ENVIRONMENTAL EVALUATION GROUP

EEG Comments on the Class 2 Permit Modification Request submitted in January 2004 concerning Packaging-Specific Drum Age Criteria for New Approved Waste Containers

**Specific Comments on the Class 2 PMR submitted in January 2004 concerning
Packaging-Specific DACs for New Approved Waste Containers**

Figure A. Diagram of a conceptual 100-gallon waste drum with inner lid and two

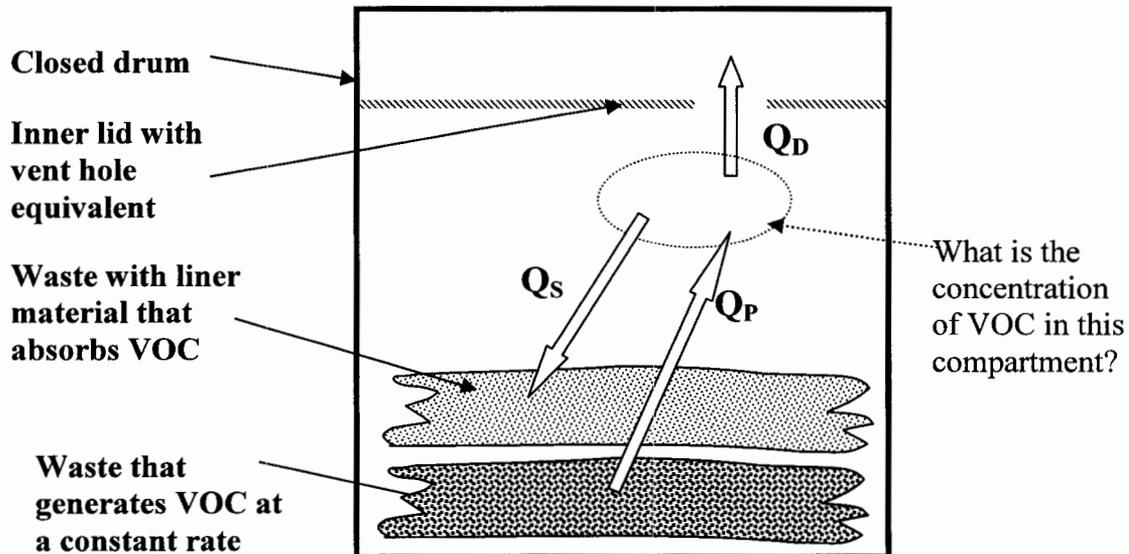
In order to understand the possible behavior of the model under the assumptions and modifications used by the Permittees, EEG re-visited the conceptual model that was used in comments made on the 13 May 2002 Class 3 DAC PMR⁵. Figure 1 in that document (See Attachment A) was revised to reflect the concept of placing a compacted drum/liner with a source of VOCs into a 100-gallon drum with other compacted drum/liners with no VOCs.

For this conceptual model, a compacted drum inside a 100-gallon drum with no liner emits a VOC at a constant rate, but the VOC then permeate through a barrier at rate Q_p (mol s^{-1}). Another compacted drum containing rigid liner material acts as a sink for the VOC that are absorbed at rate Q_s . VOC may also leave the headspace through the filter vent (modeled as a hole of appropriate size) in the inner lid at rate Q_D .

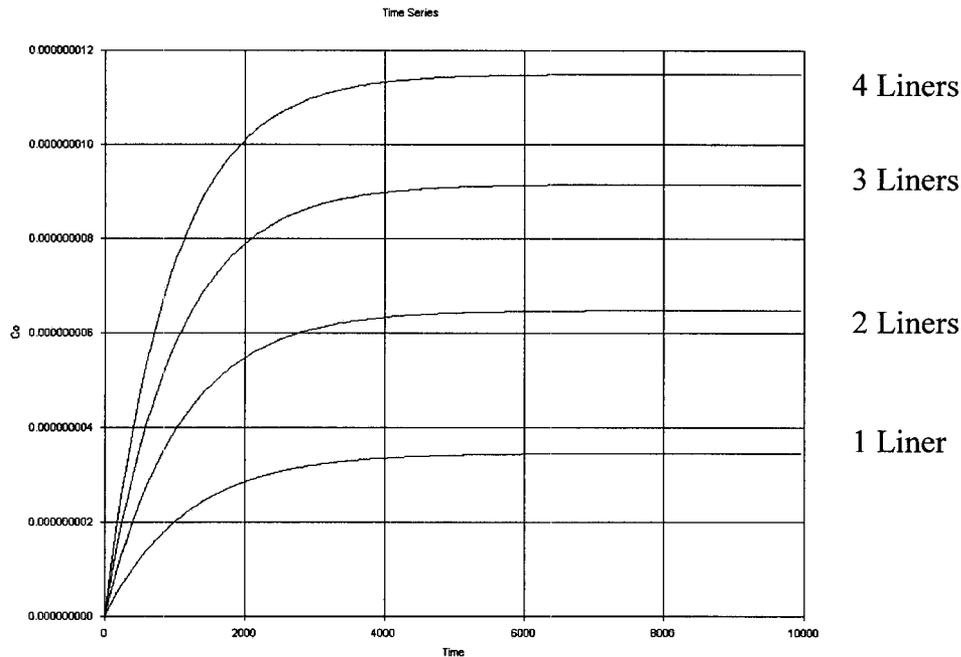
It appears that the model may be sensitive⁶ to the amount of plastic rigid liner material that is in a 100-gallon drum. Although the actual DAC may not vary significantly based on the amount of liner material present in the container, the point is that the actual VDRUM model should be examined for such a possible sensitivity. The Permittees' comments to EEG and to NMED did not consider the volume of plastic, container material when they discussed the hypothetical movement of VOC inside a 100-gallon drum. However, in describing the equations used to create the VDRUM model, Connolly et al. (equation A-4, p. A-2, referenced in Appendix A) state that the rate of VOC accumulation, in part, is a function of how soluble the VOC is in the plastic and the total volume of plastic, V_p . Whether or not the plastic is breached, crushed, or placed in bags is not considered in the VDRUM model.

EEG disagrees with the Permittees' statement (p. 6 of the March 2004 draft 'companion' document) that, "The net result is bounded by the case of a waste 55-gallon drum containing a liner assumed to be saturated before supercompaction." Fig. B indicates that the equilibrium time, or DAC, may vary with the amount of liner material in the 100-gallon drum. If the Permittees do not assume that the 55-gallon drum liner is already saturated, then it becomes another liner that will absorb VOC and the DAC could actually be longer. The bounding case of a pre-saturated liner is also not supported

EEG, therefore, based on a crude analysis of the sensitivity of the DAC calculational model, maintains that the Permittees have not supported their assumptions of the adequacy of the VDRUM model to simulate VOC transport inside the 100-gallon drum under certain conditions. EEG believes that the Permittees could simulate various waste packaging scenarios using the VDRUM input files, vary VDRUM parameters that may affect the scenarios, run and re-run the actual VDRUM code, and report the results of such experiments to clarify and support their assumptions in a more technical manner.

Figure 3. Crude Sensitivity Analysis on DAC Model – continued
Parameters having significant effect on model output.

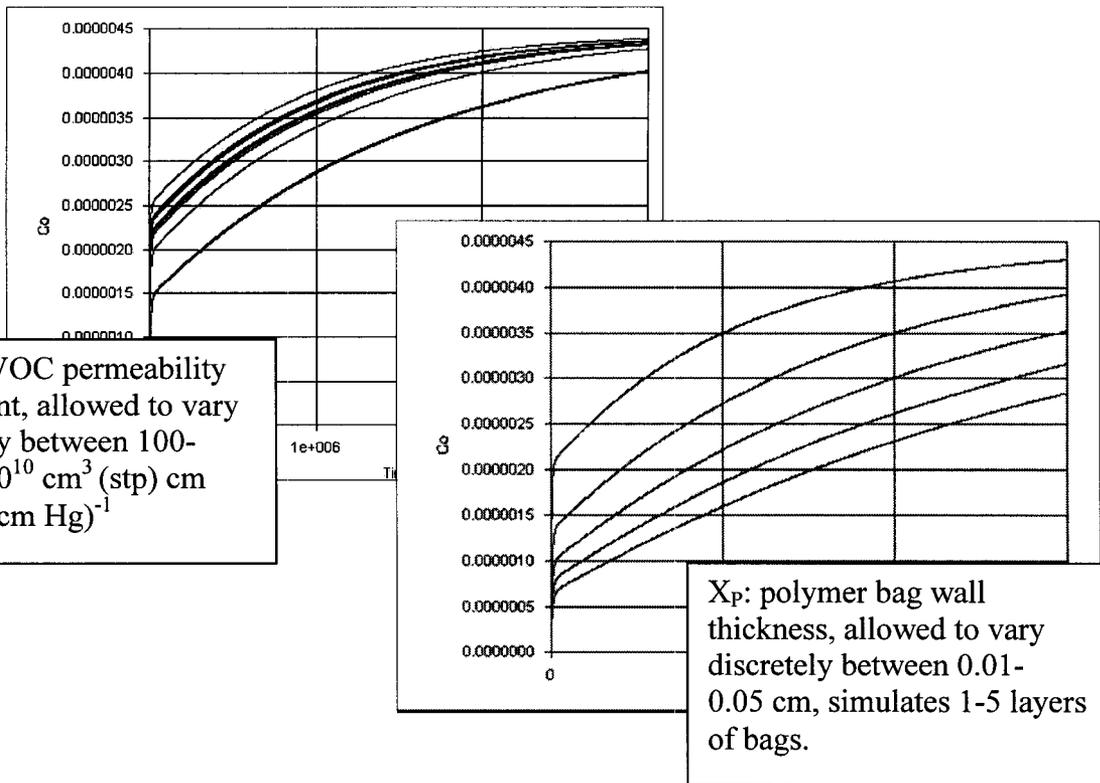
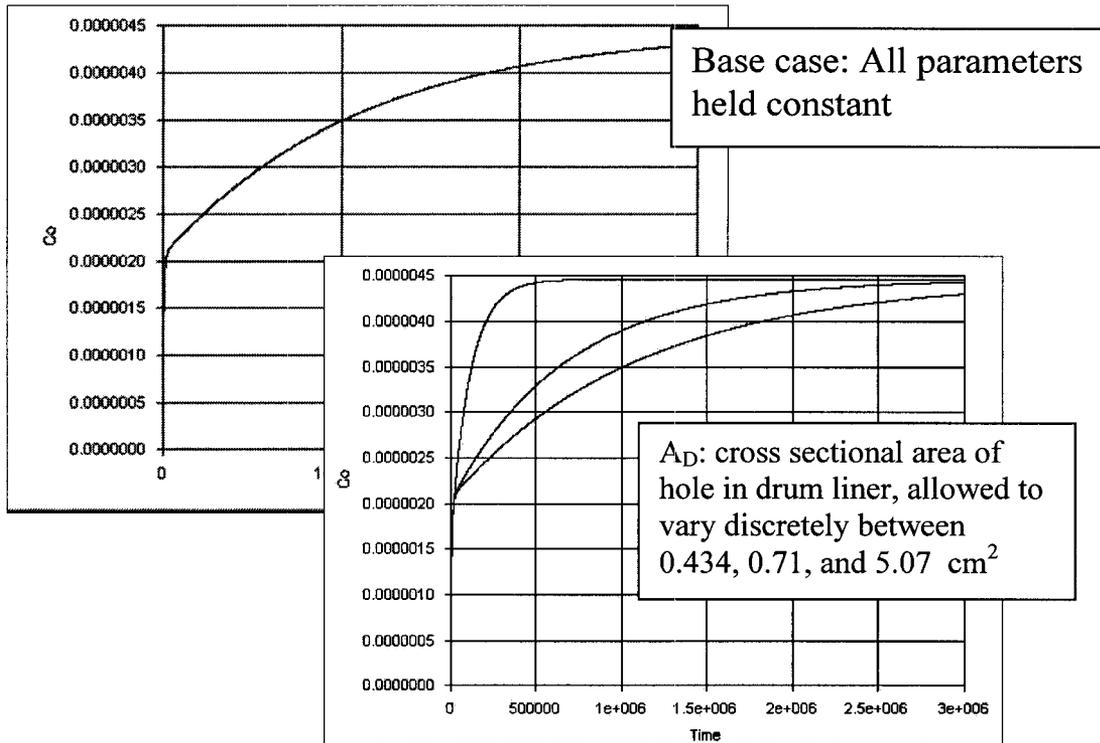
It appears clear, based on Figure 3, that the diameter of the hole in the drum liner lid (A_D) and the thickness (or number) of plastic bags containing the waste (X_p) have a pronounced impact on how fast the VOC will reach equilibrium concentration. This confirms the permittees' claims that package configurations where these values are optimized will result in shorter DACs. One may conclude, also from Figure 3, that the permeability coefficient (ρ or rho) might significantly affect the DACs as well. This suggests that the time to reach equilibrium concentration throughout the drum is VOC dependent and not strictly packaging dependent as suggested by Liekhus et. al. (2000).

The sensitivity of the DAC to these three parameters requires that the measurements or other methods used to determine the values of the parameters be checked very carefully. On the other hand, using the most conservative known values may be necessary. Acceptable Knowledge programs will be crucial to ensuring that the correct DAC has been selected.
